VALUE ENGINEERING STUDY
OF
SR 104/ RIVERWATCH PARKWAY

PROJECT NUMBER: DE-00MS(389)
PI NUMBER: 262750

ATLANTA, GEORGIA
December 4 and 5, 2006

AS PROPOSED MULTI-USE TRAIL CULVERTS

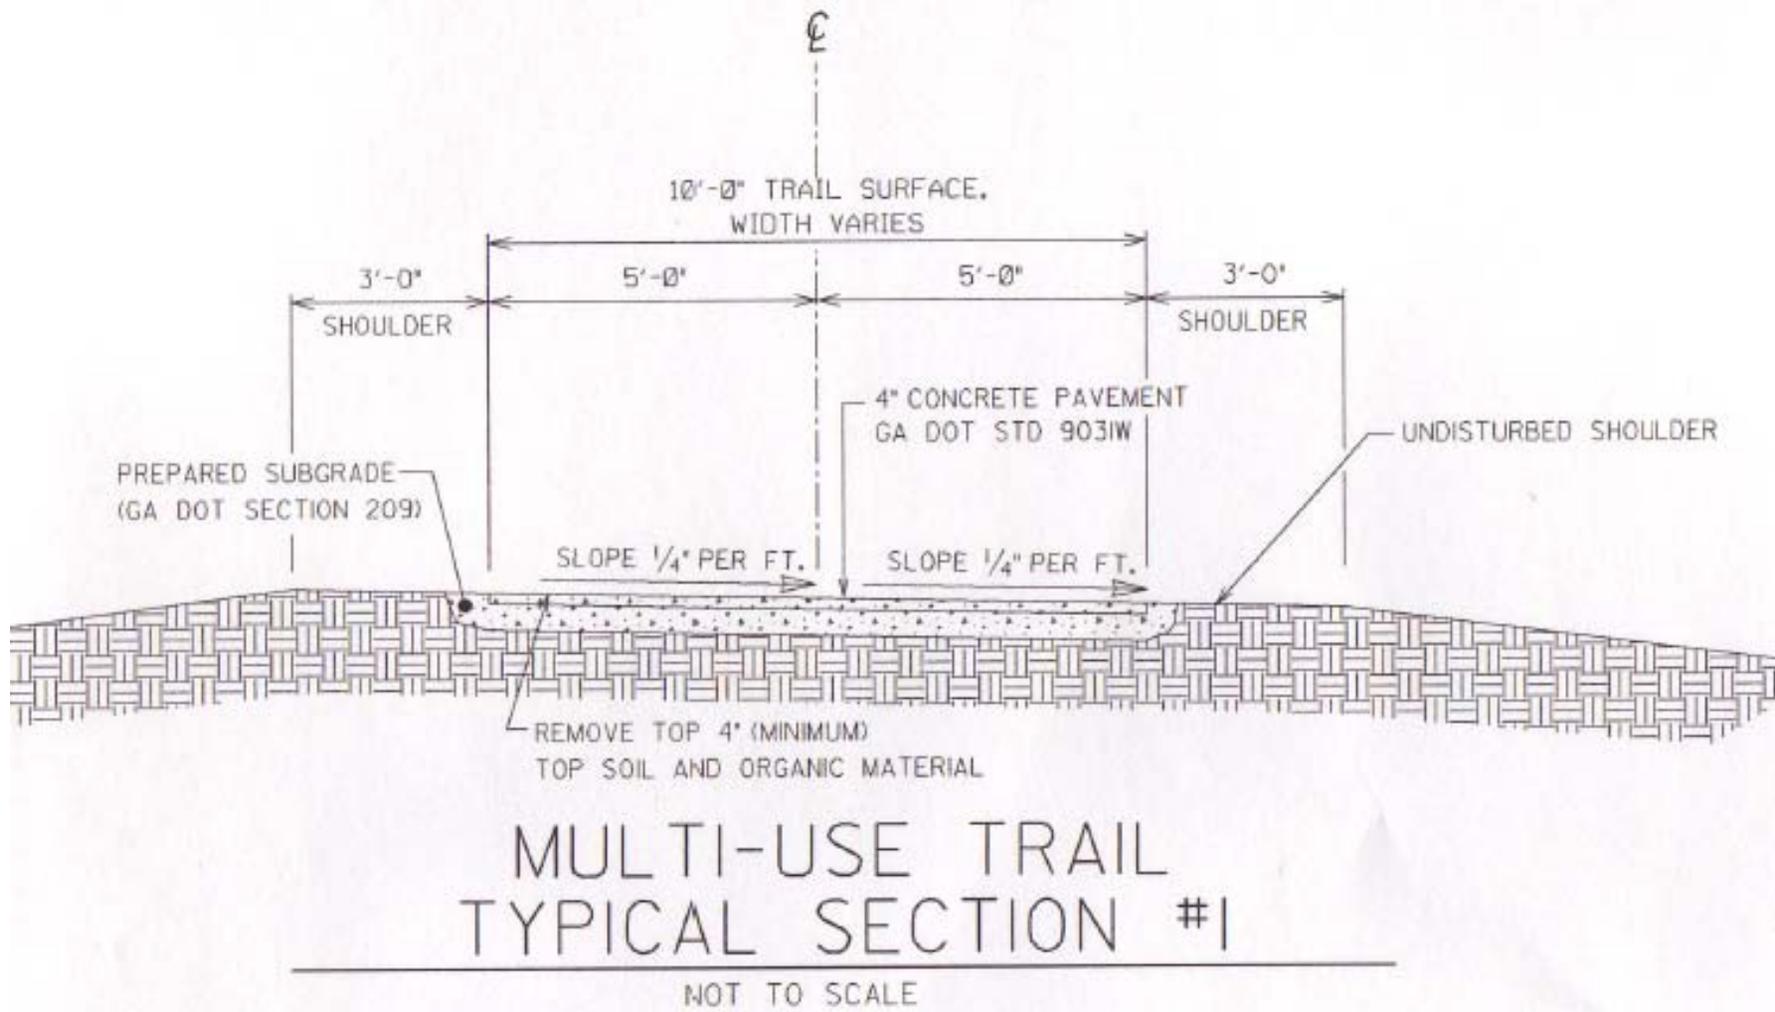
The proposed project contains a Multi-Use Trail on both the levees along the Augusta Canal 1st Level. The trail will shift away from the canal to pass through arched culverts that will be constructed under the approaches to the St. Sebastian Way Bridge as shown on the following pages.

VALUE ENGINEERING ALTERNATIVE MULTI-USE PATH UNDER BRIDGE END ABUTMENTS

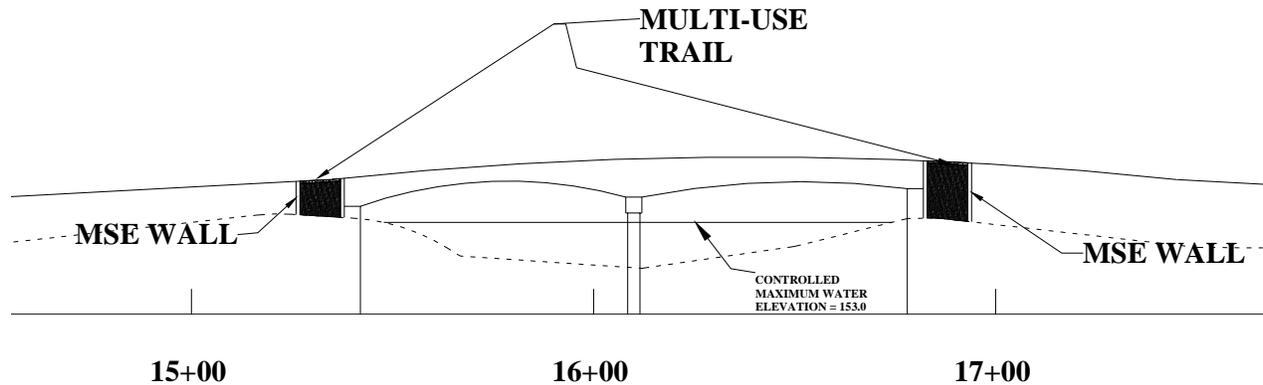
The Value Engineering Team recommends extending the lengths of both spans of the St. Sebastian Way Bridge to accommodate the Multi-use Trails as shown below:

This alternative will shorten up the length of the trail, keep the grade separation between St. Sebastian Way and the Trail and also provide for an open Trail rather than putting the Trail users in a tunnel. It will require a longer structure to span the Trail and Canal and then will have to be encased in a topless culvert to keep the integrity of the levee.

**VALUE ENGINEERING ALTERNATIVE NUMBER 2
AT GRADE MULTI-USE TRAIL**

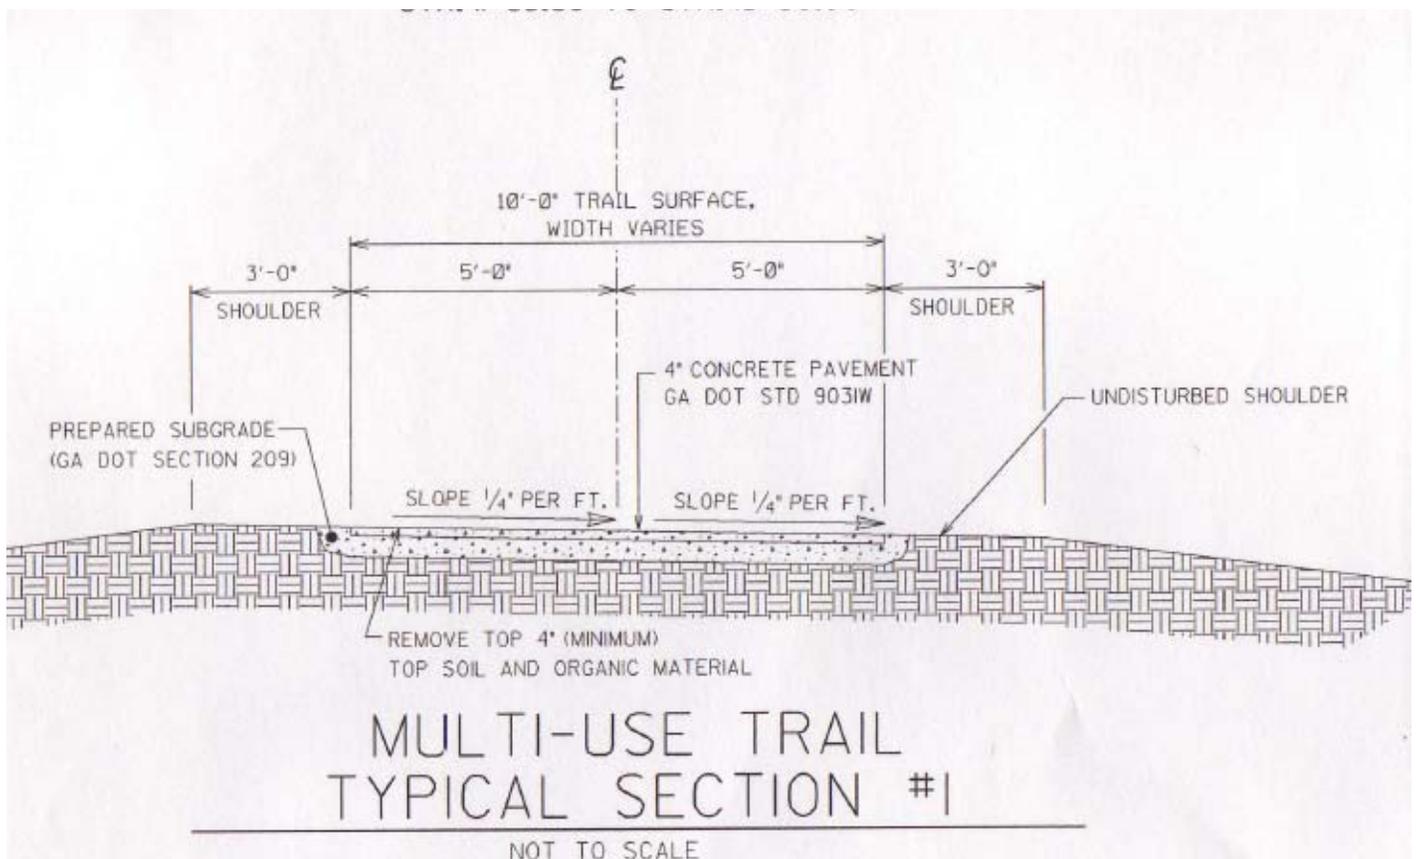
Another approach to accommodate the Multi-Use Trail is to raise it to the proposed grade of St. Sebastian Way for an at grade pedestrian crossing. This will eliminate the need to construct an arched culvert. The profile of the Trail would not exceed a 12:1 grade ensuring compliance with ADA. The Trail approaches to St. Sebastian will have to be constructed using a retained earth wall. A pedestrian signal may be needed to stop St. Sebastian Way traffic in order for the Trail users to cross St. Sebastian Way.

VALUE ENGINEERING ALTERNATE MULTI-USE PATH PAVEMENT

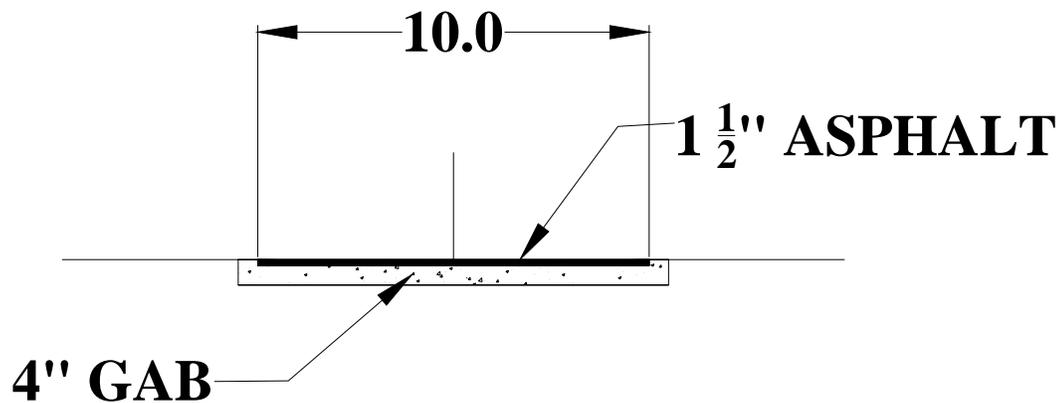
The Value Engineering Team recommends replacing the 4" Concrete pavement with 1.5" of asphalt and 4" of GAB.
